SAF Trailer Air Suspension and Mechanical Sliders

Slider pin linkages changing from 1/2" diameter to 3/8" diameter

Effective September 2015

Figure 1 - Pin Linkage Rods

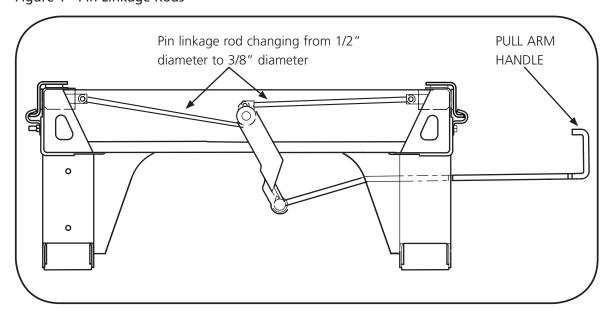
SAF-HOLLAND will change the diameter of the pin linkage rods from 1/2" to 3/8" for all outside shim slider models (Figure 1). Inside shim models will not be affected. This change will not affect the form, fit, function, or durability of the locking mechanism. The new 3/8" diameter linkage rods are completely interchangeable with the previous 1/2" diameter design.

The following models are affected: CBX40, CBX46, CBX50, CBX69, ULX40, UltraLite and Z-Frame.
